# EnBW and bp joint response to Ofgem “Minded-to Decision and further consultation on Pathway to 2030”

## Appendix 1 – EnBW and bp response to National Grid ESO HND consultation

## Executive Summary – 04 - Coordinated Design East Region

**Figure 1 HND recommendations for Scotland East Coast**

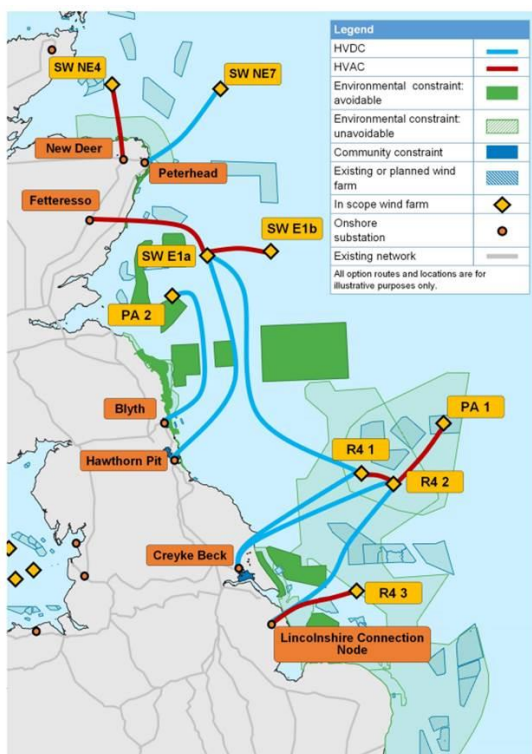
The new Tender Entry Condition could possibly work for simple coordinated offshore transmission systems, however for the complex, meshed HVDC system proposed by HND round 1 for our Morven project (SW E1a) it raises concern.

In the simplest reading of the proposal from the developer point of view, we would require one HVDC 1.5GW link from our Morven project (SW E1a) to Hawthorn Pit, with additional AI to connect to the HVAC system (which would not be for our use). However, the new Tender Entry Condition model bears the risk for the developer to build significantly more infrastructure than simply needed to connect our windfarm to the grid.

For our Morven project alone, the HND output appears to place the responsibility of two 1.8GW HVDC transmission systems (combined route length greater than 750km), one containing a multi-terminal HVDC interlink to the Dogger Bank projects and one 2GW HVAC network (route length greater than 150km) linking Fetteresso with our project and the adjacent SW E1b project.

This would increase the investment level for the transmission part of the project far beyond the investment level for the windfarm itself.

In our HND response to National Grid ESO (see Appendix 1 – EnBW and bp response to National Grid ESO HND consultation) we provided a modular approach to improve deliverability and cost effectiveness for the East Coast system which provided equivalence for social and environmental impacts. Unfortunately, these recommendations have not been incorporated and now represent a significant deliverability challenge to the transmission system for all developers. For that reason we recommend the inclusion of a HND due diligence stage as set out in our proposal under question 4 below.

# SLD Option 1d – Preferred Recommendation

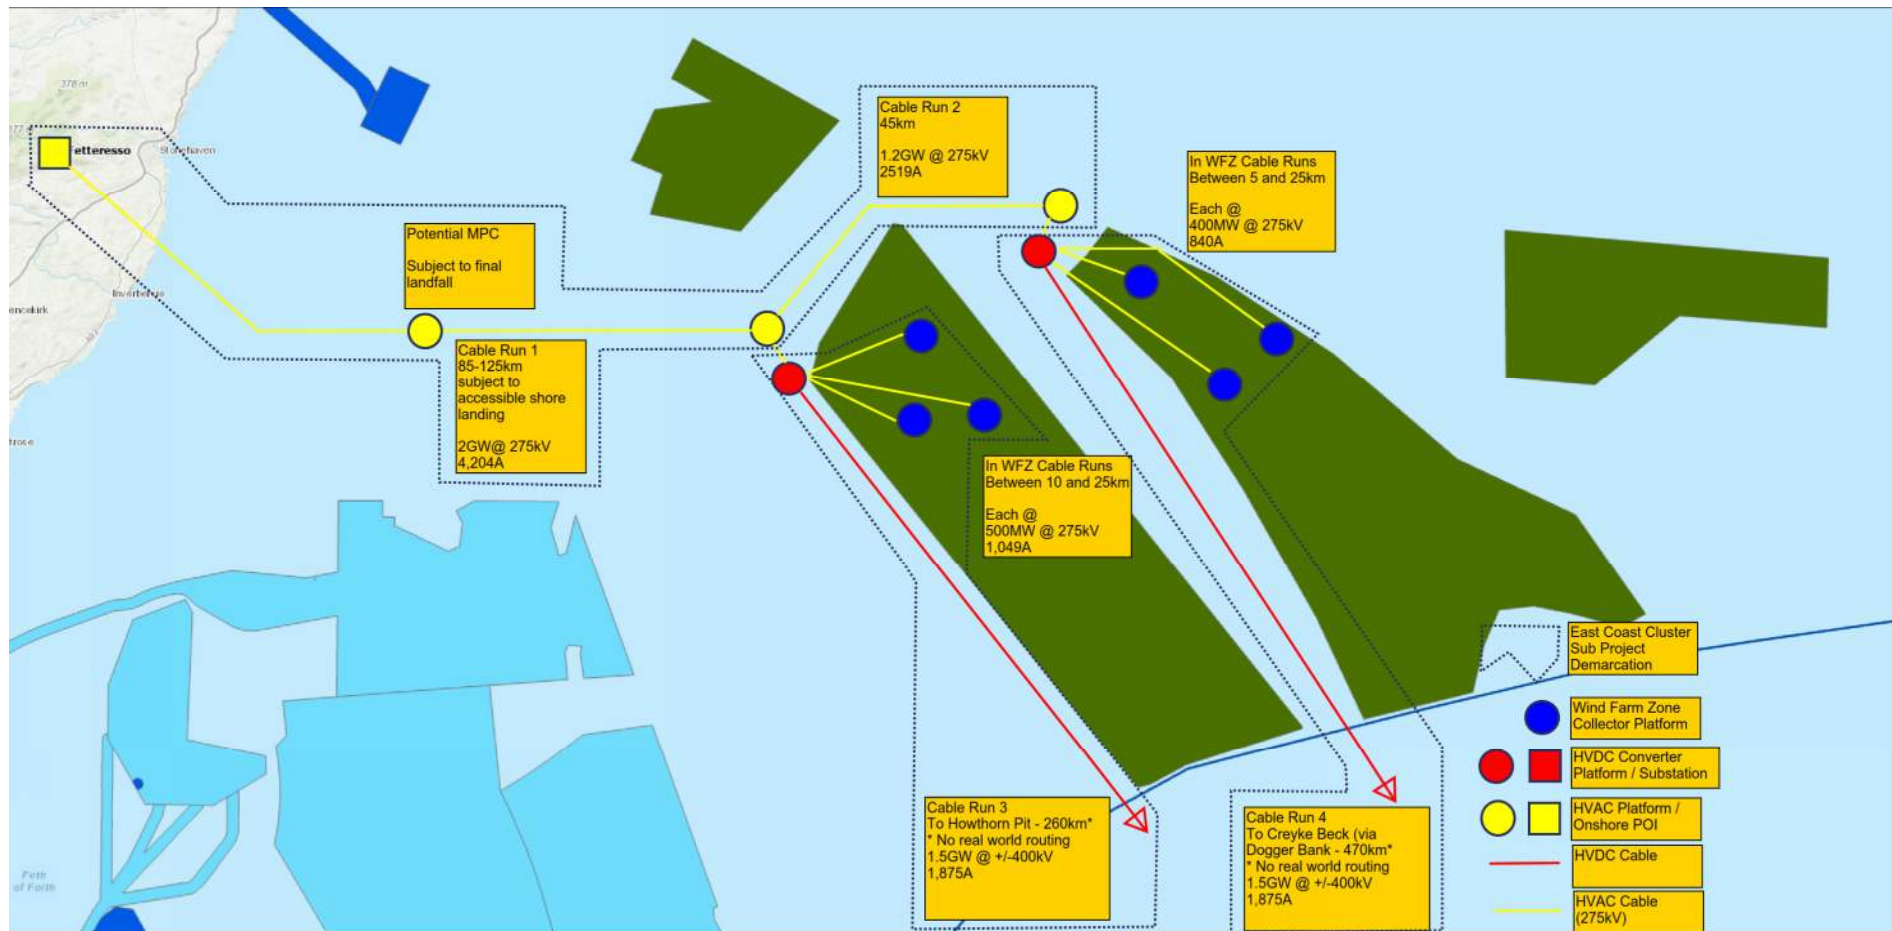
- We are recommending the phase approach for the overall design.
- This approach assumes a level of temporary TEC may be provided to Fetteresso to accommodate the Morven development via HVAC to ensure 2030 delivery.

- The Morven to Hawthorn HVDC link may be developed in parallel to accommodate long term incremental capacity from the East Coast Cluster to Hawthorn Pit with a predicted delivery of 2032.

- Furthermore, interconnection within HVAC platform will provide more coordination between all windfarm projects within the Cluster.
- With phase approach will provide opportunity to NGESO to optimise the Anticipatory Investment requirement considering the future need case.

# SLD Option 1a

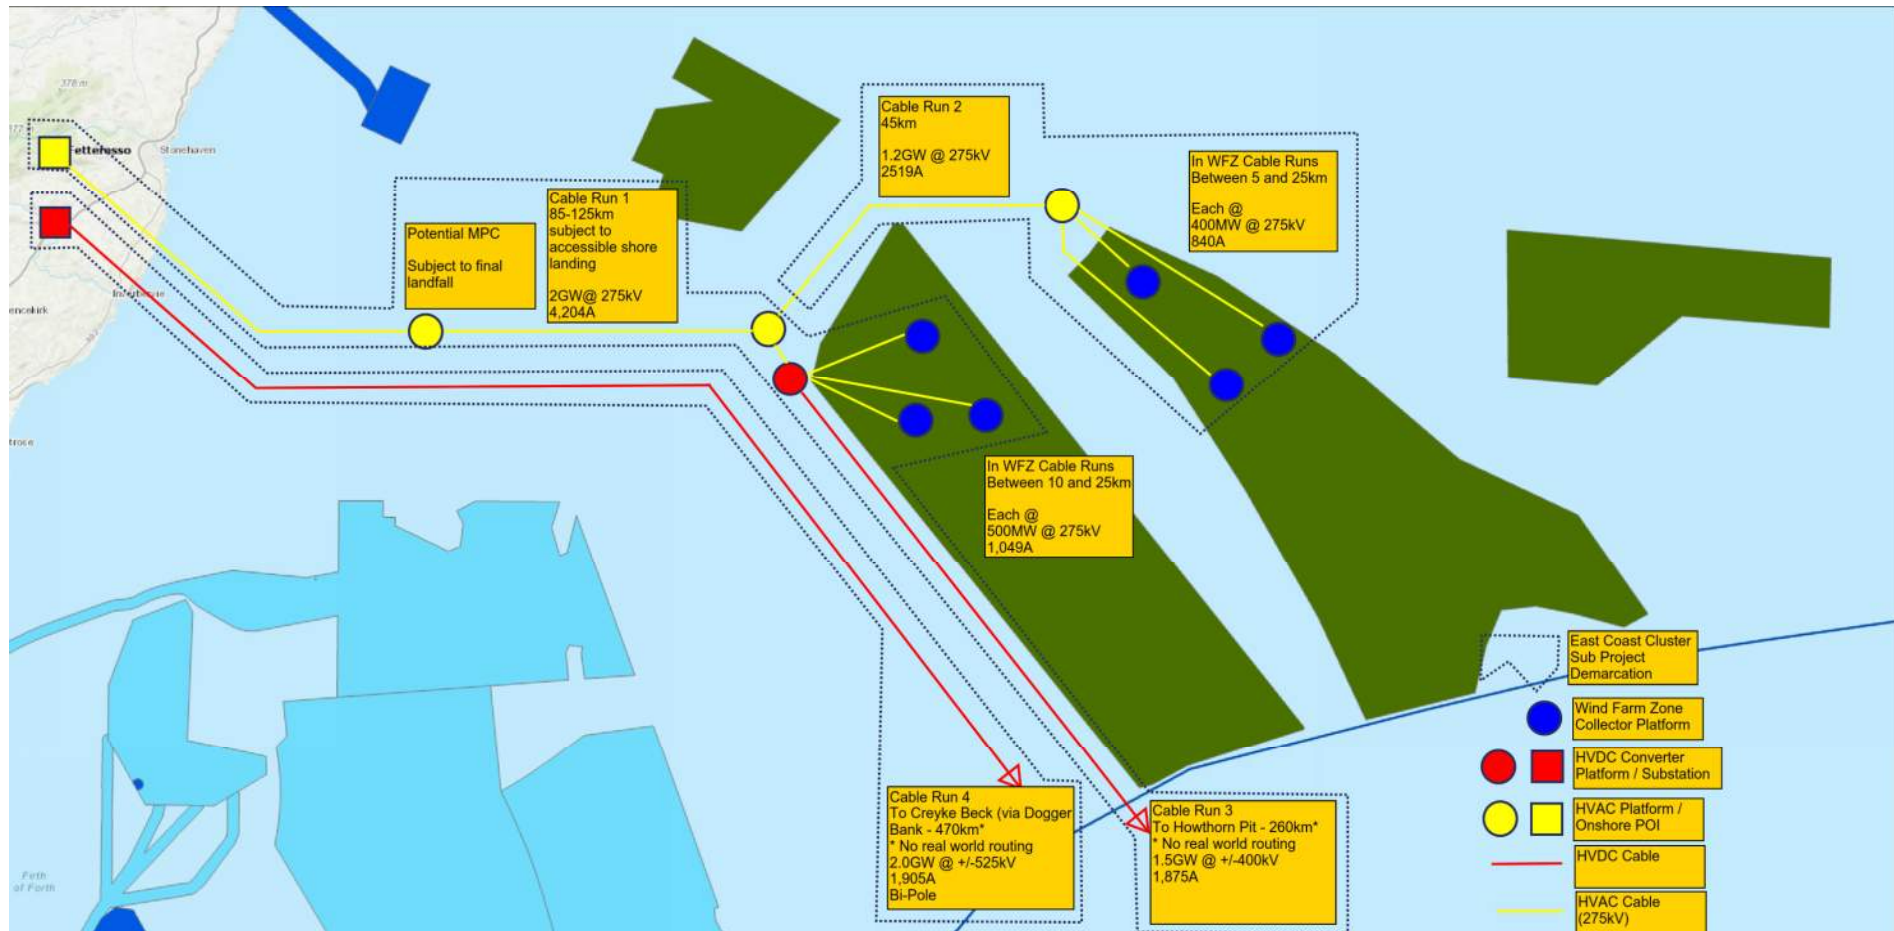
- This arrangement includes a maximum HVDC converter size of 1.5GW, as do all presented alternative. This is aligned with our concerns over 525kV voltage level technology readiness for HVDC in offshore environments considering lifting capacities in the UKCS North Sea.

- We are recommending the phase approach for the overall design.
- This approach assumes limited capacity at Fetteresso and HVAC link provides the incremental capacity to manage the power flow.

- Furthermore, interconnection within HVAC platform will provide more coordination between all windfarm projects.
- Phased approach will provide opportunity to NGESO to optimise the Anticipatory Investment requirement considering the future need case.

# SLD Option 1b

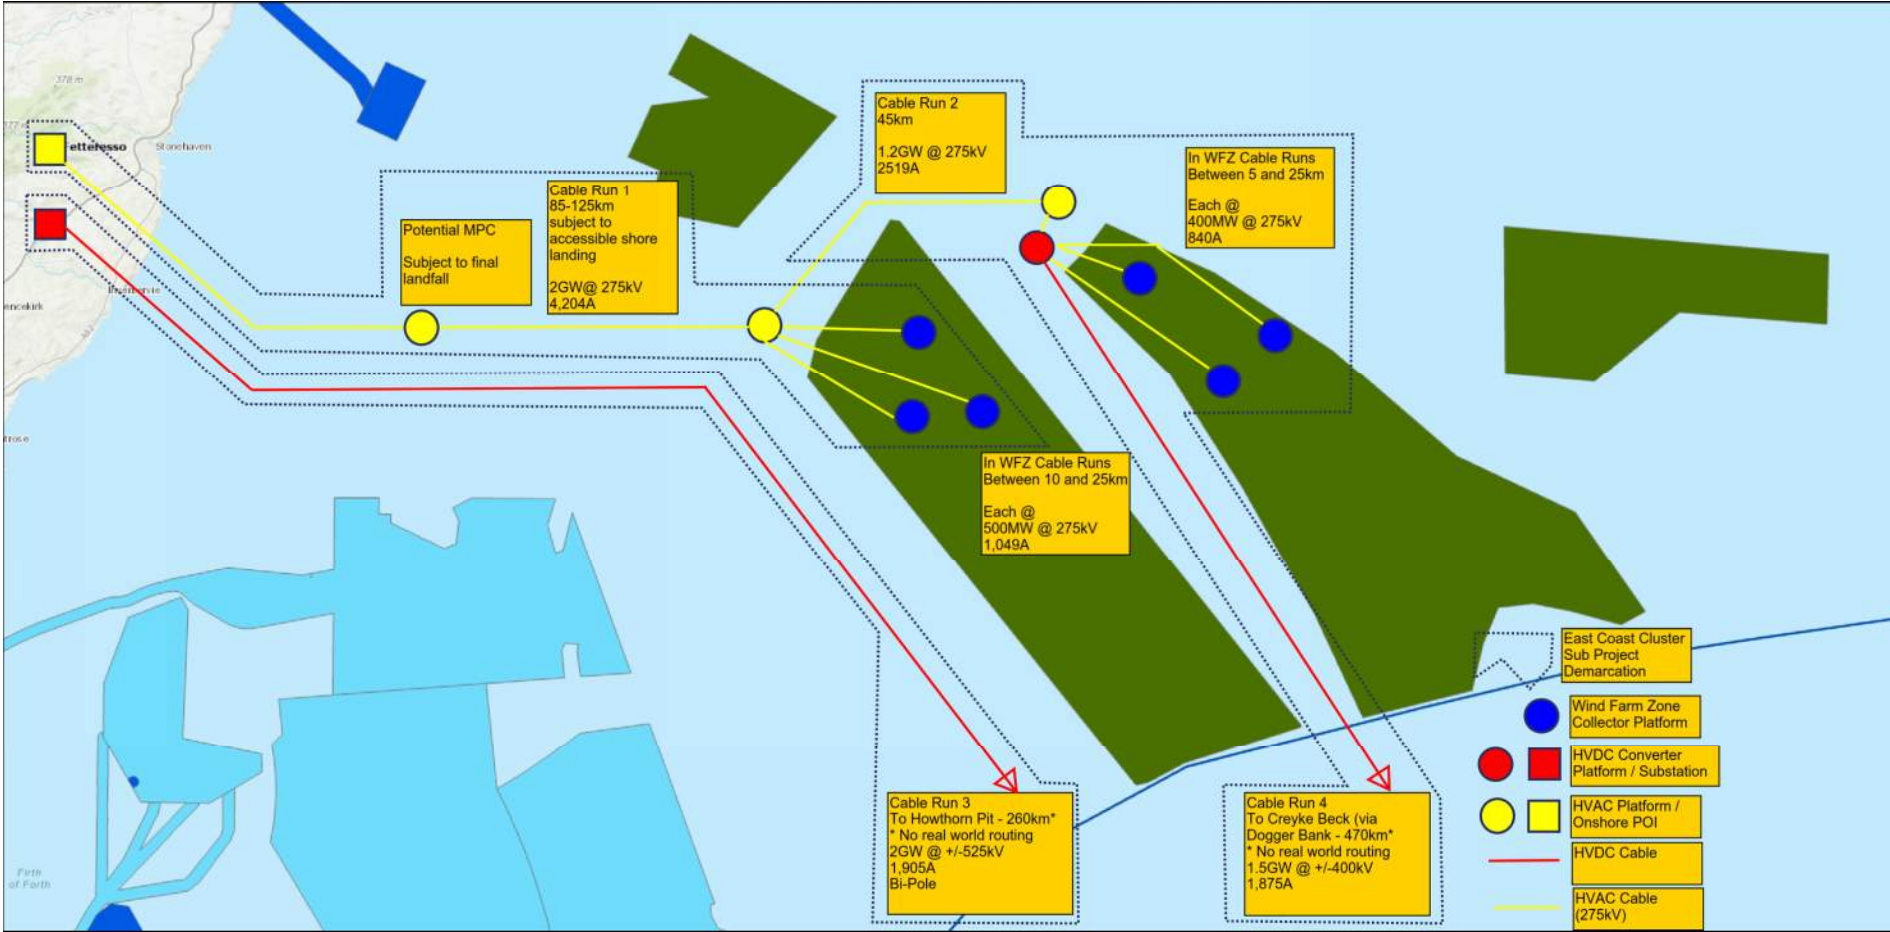
- We are recommending the phase approach for the overall design.
- This approach assumes HVAC link between Fetteresso, Morven and SW\_E1b provides capacity for SW\_E1b to Fetteresso Bootstrap.

- HVDC link between Morven and Hawthorn Pit provides the necessary works to accommodate Morven generation.
- HVDC link between Fetteresso, R4\_1 and onshore Scottish network to Creyke Beck (via Dogger Bank) provides the necessary works for further incremental capacity to accommodate SW\_E1b WFZ generation.

- One residual benefit is the onshore HVDC bootstrap can be sized to 2GW inline with other Easter Link onshore to onshore bootstraps.
- Interconnection within HVAC platform will provide more coordination between all windfarm projects.

- With phase approach will provide opportunity to NGESO to optimise the Anticipatory Investment requirement considering the future need case. To accommodate SW\_E1b

# SLD Option 1c - Commentary

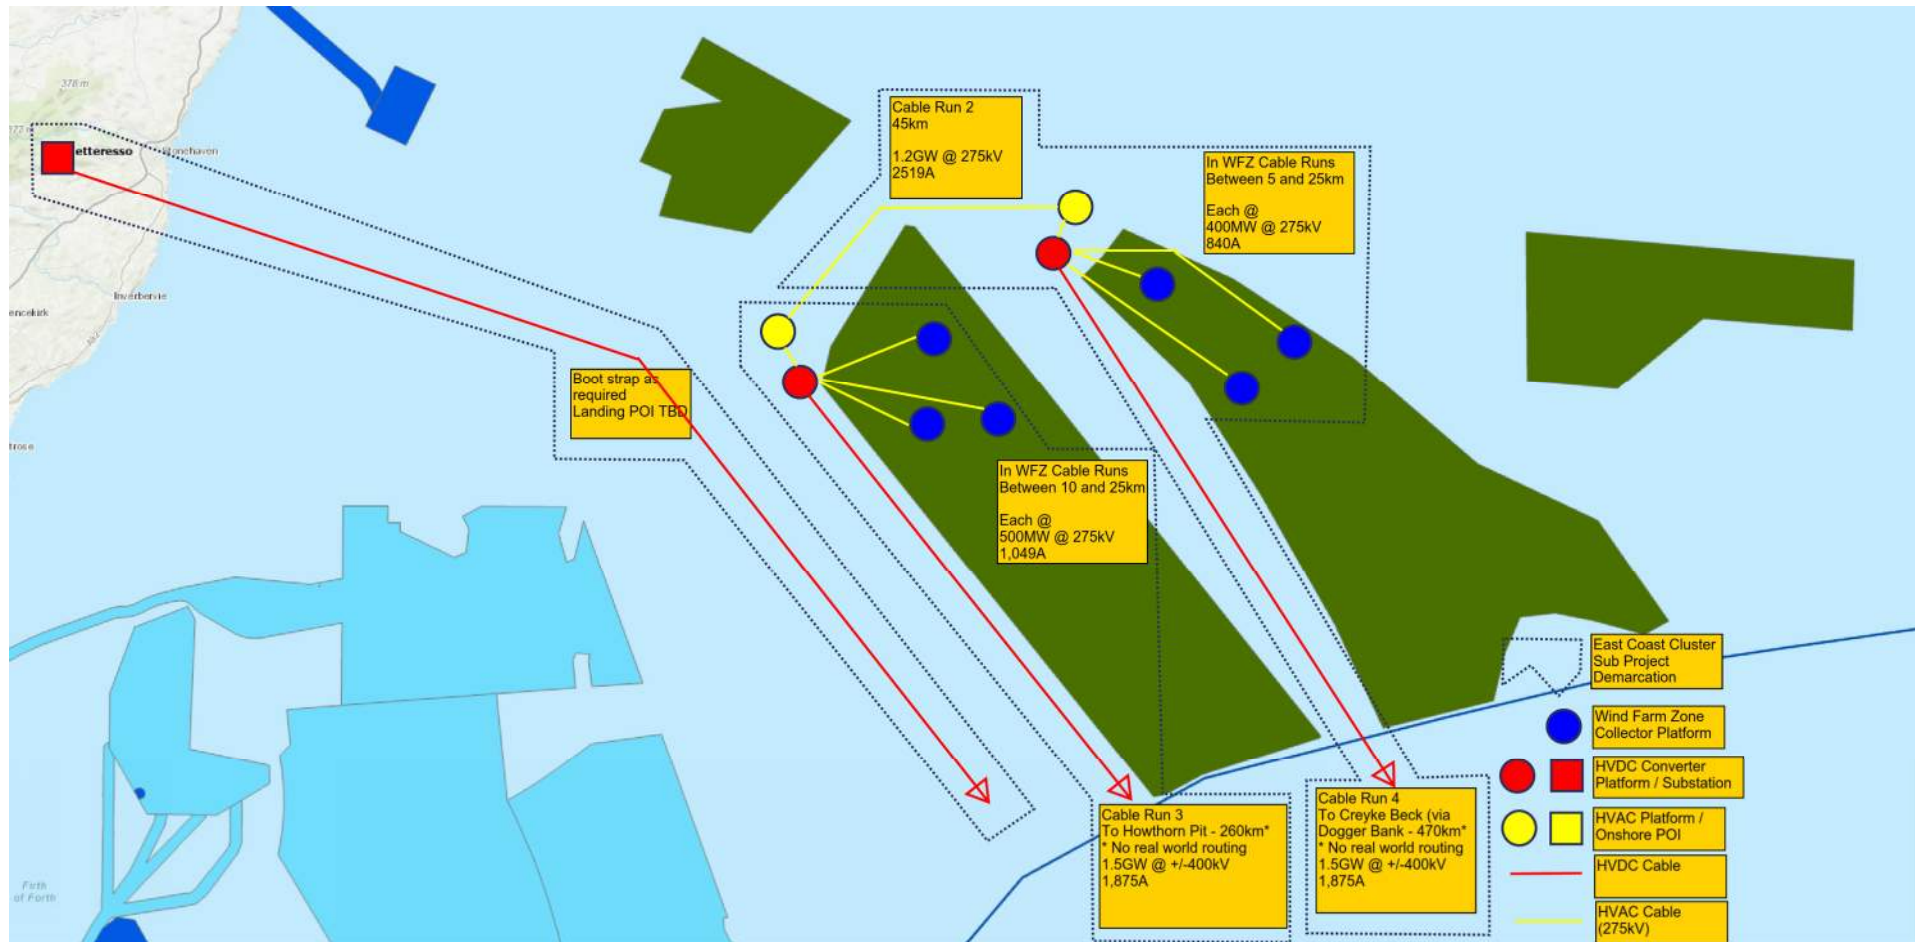
- Furthermore, interconnection within HVAC platform will provide more coordination between all windfarm projects.
- With phase approach will provide opportunity to NGESO to optimise the Anticipatory Investment requirement considering the future need case.

- This design relies upon temporary TEC at Fetteresso to secure a level of power entry while the Bootstrap Construction is completed.

HND Objective	
Economic and efficient	+ Significant cost reduction as a result of AC to DC conversion take place onshore
Deliverable and operable	<ul style="list-style-type: none"> <li>+ Platforms can be delivered as single lifts with minimum offshore hook-up</li> <li>+ Segregation of programme into smaller projects reduces overall project complexity and dependencies.</li> <li>+ Greater onshore scope content ensures higher deliverability compared to offshore</li> <li>- Very challenging landfall may make additional cable content non-feasible. (This can be mitigated by assessing optimum POI for onshore HVDC landing or can be consider as offshore extension to HVDC as Phase 2)</li> </ul>
Minimise environmental impact	<ul style="list-style-type: none"> <li>- Increase onshore substation size</li> <li>- Increase cable corridor</li> </ul>
Minimise local community impact	<ul style="list-style-type: none"> <li>- Increase onshore substation size</li> <li>- Increase cable corridor</li> </ul>

# SLD Option 2

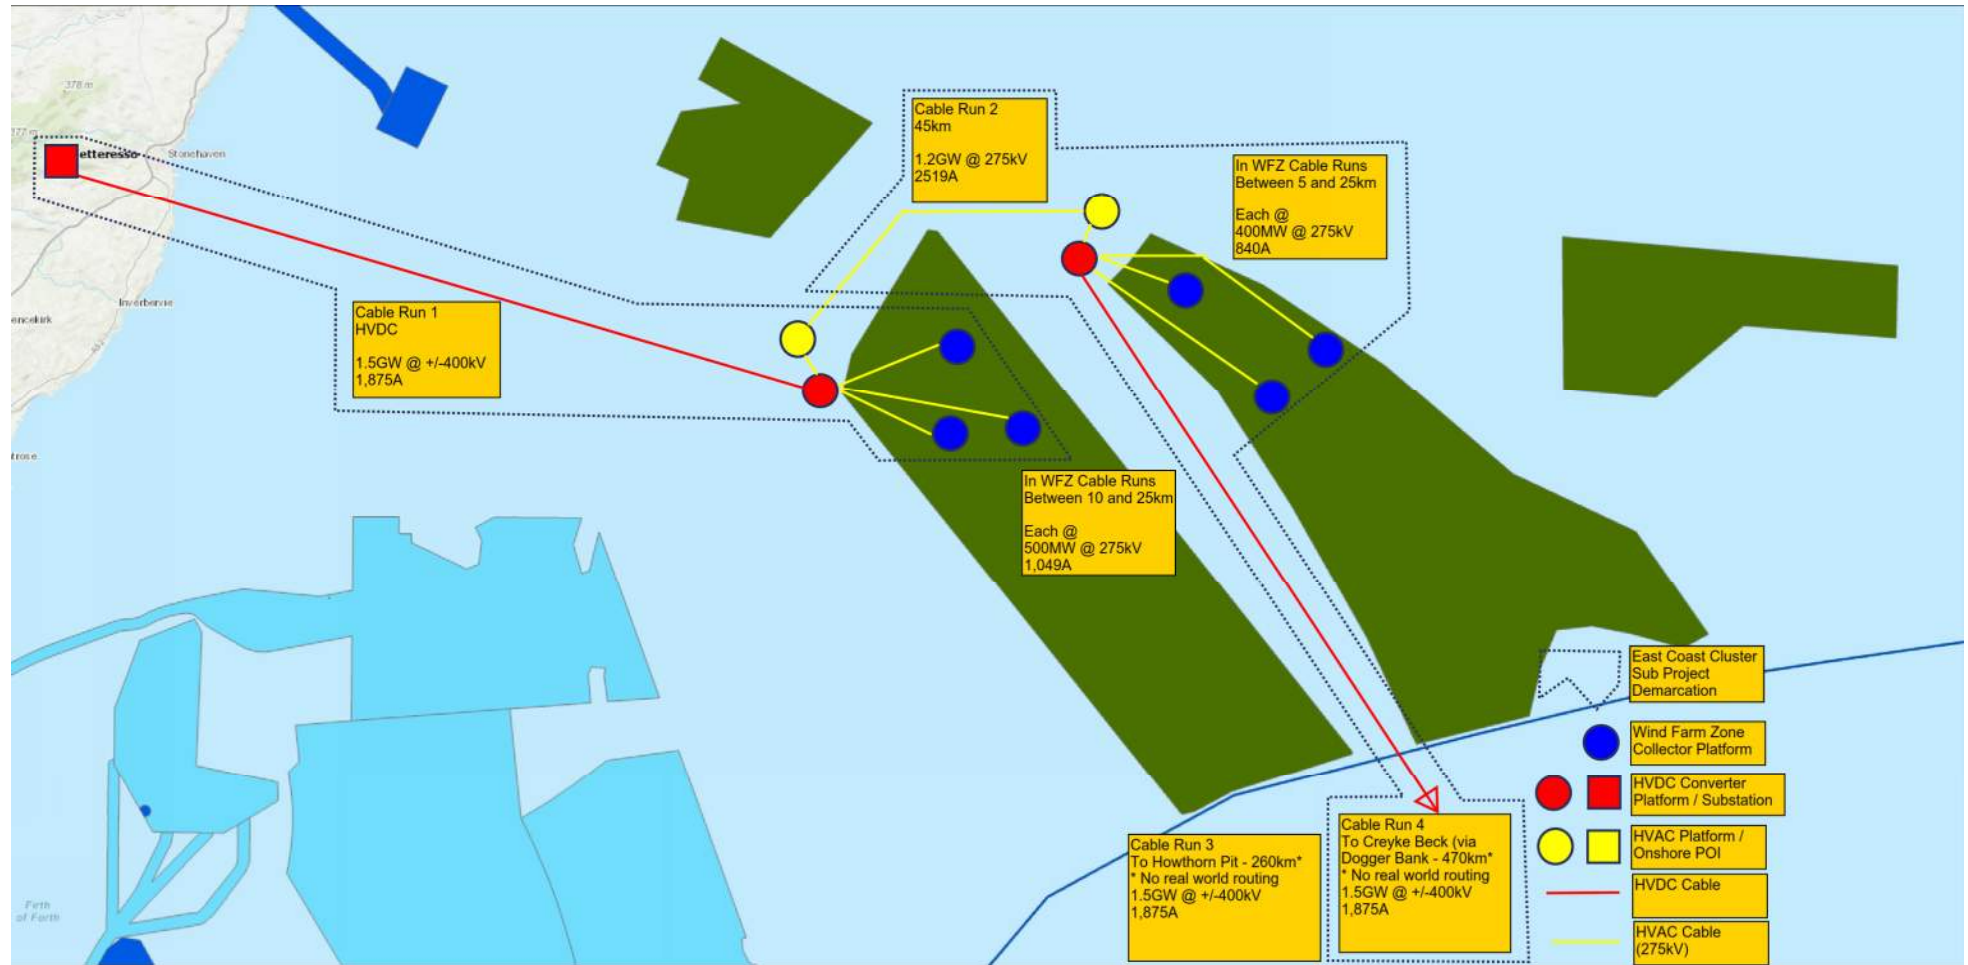
- One of the key technical concerns over the HND base case is the overall cable length associated with the HVAC element of the programme between Fetteresso and the Windfarm Zones. This is further compounded by the technical challenges and limited landfall access along the Aberdeenshire Coastal line, where there are very few cable landing points available and moving from a HVAC solution to DC provides a significant reduction in cable way requirements.

- HVDC bootstrap from Fetteresso implemented to England POI to increase North South incremental capacity as required.
- HVDC link between Morven and Hawthorn Pit provides the necessary works for further incremental capacity to accommodate Morven generation.

- Furthermore, interconnection within HVAC platform will provide more coordination between all windfarm projects.
